Subject: Additional information regarding the replacement of Bridge No. 8 over

Drowning Creek on SR 1203/1412 (Turnpike Road), Hoke and Scotland

Counties, North Carolina. Federal Aid Project No. BRZ-1203(2),

TIP Project B-4967.

UTILITY PERMIT DRAWING SHEET 2 OF 3 NOV. 02, 2015

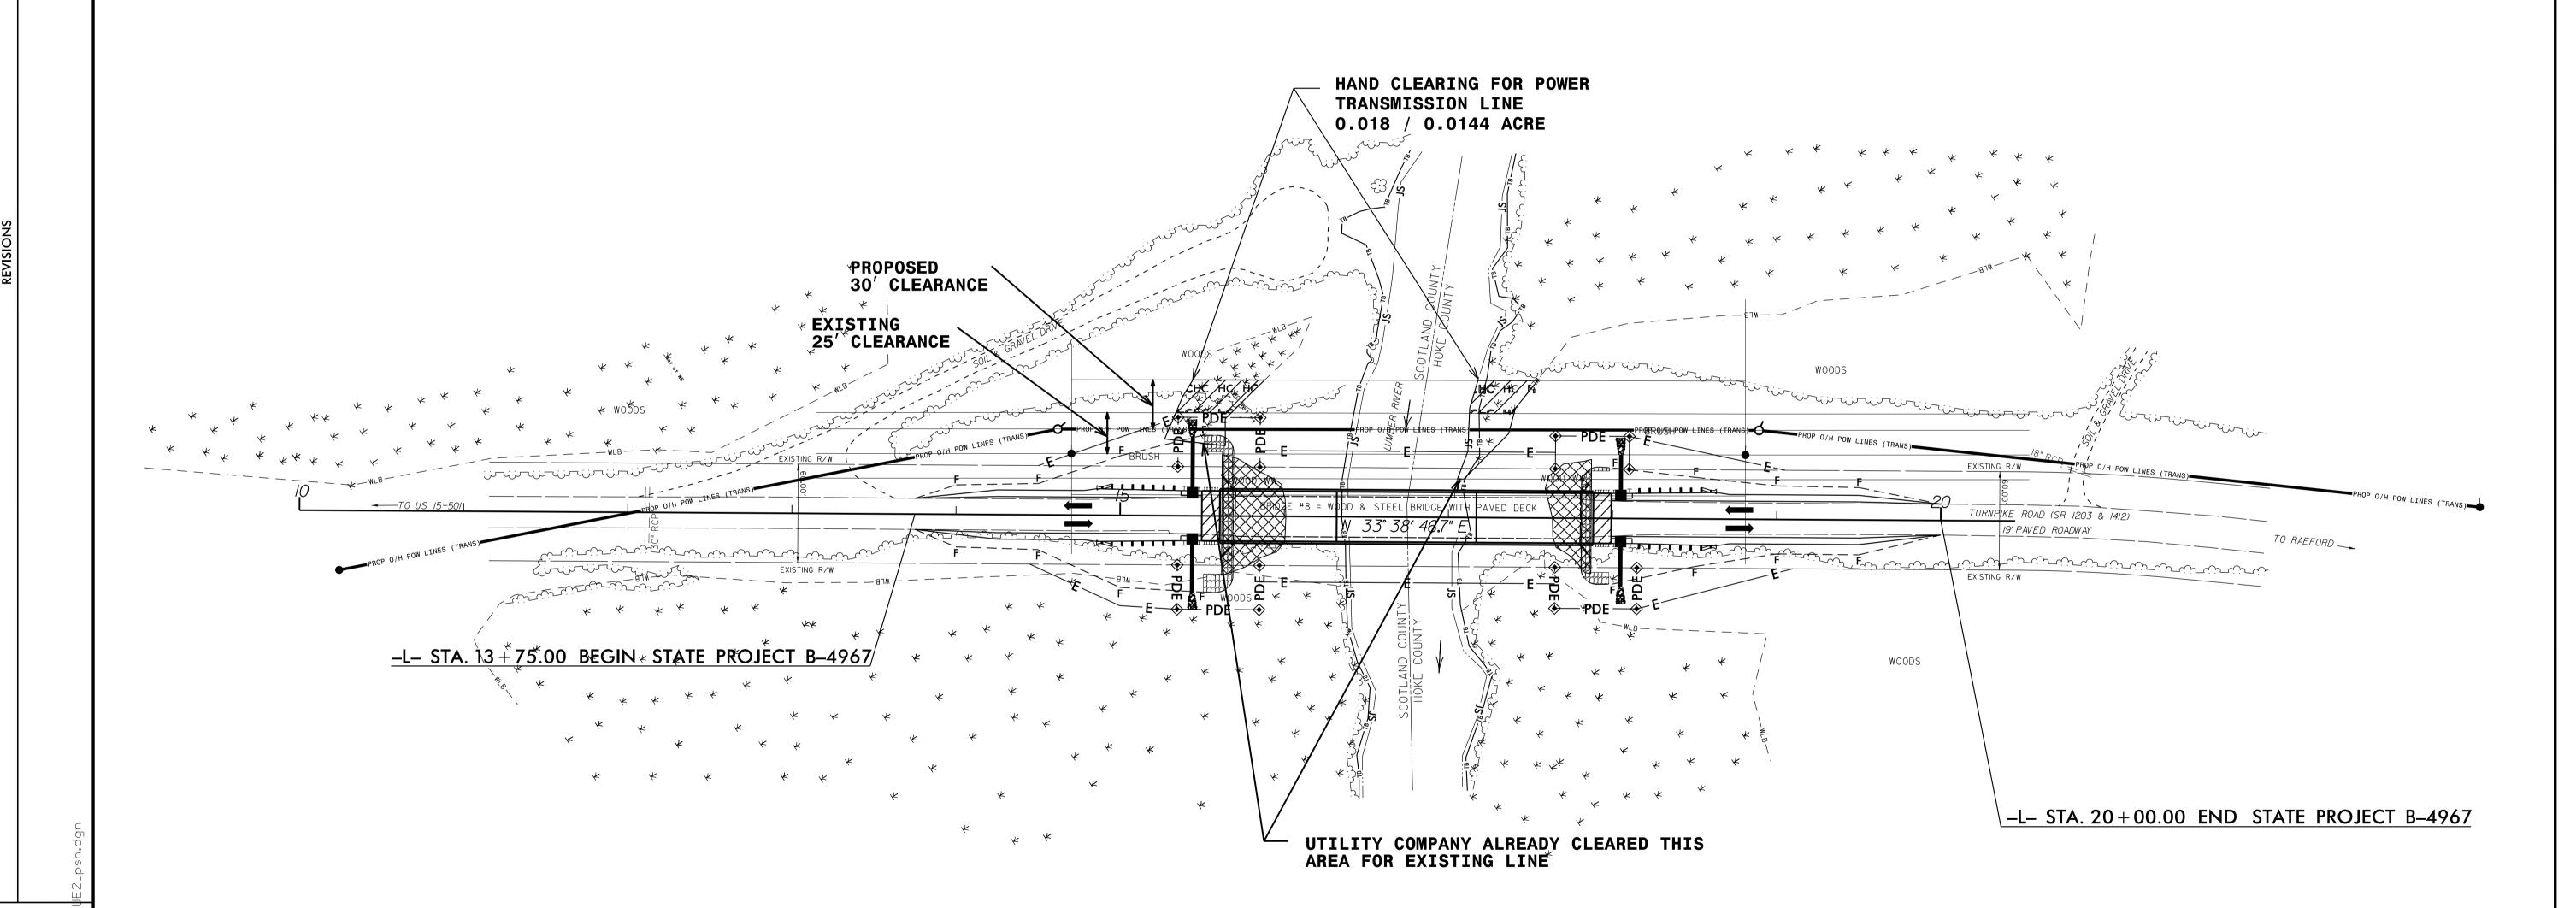
Additionally, NCDOT also has updated information regarding the impacts of proposed utility work on B-4967. The relocation of power transmission poles will involve handclearing 0.03 acre of wetlands. Enclosed you will find the permit drawings depicting this work.
